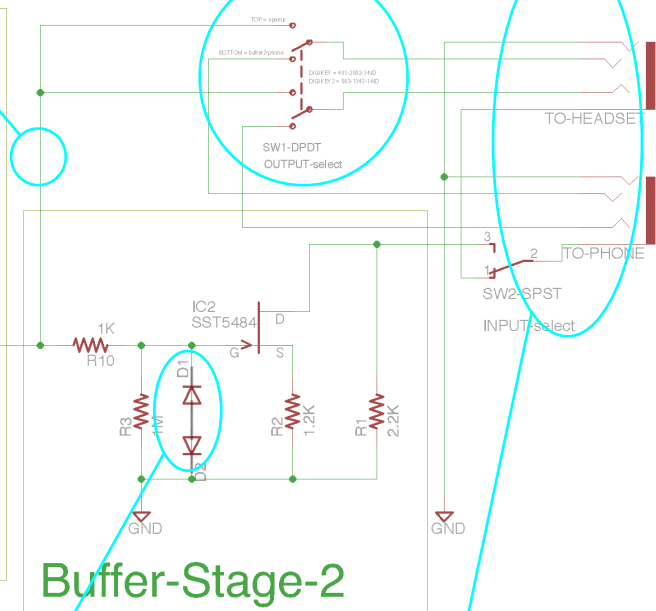
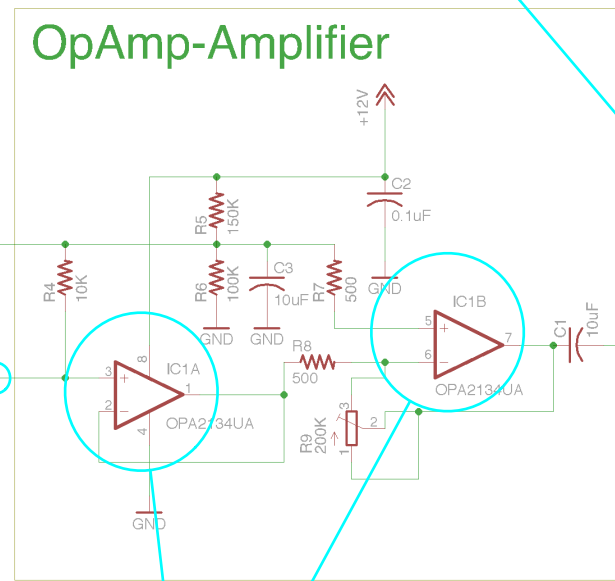
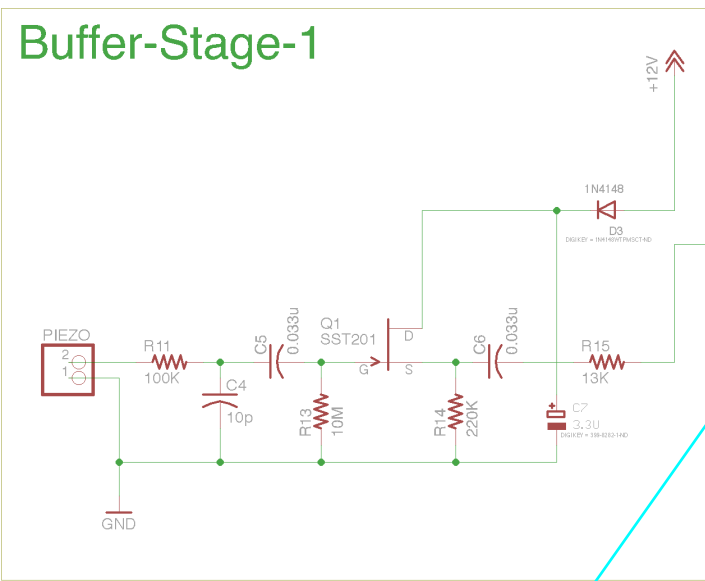
Change package to the better switch listed as "Digikey2)

Do we need a Resistor here?

What goes here?
Test on bread-board

Change to TL072
same package

Change to Zeners

Change to
Digikey CP-43514SJCT-ND
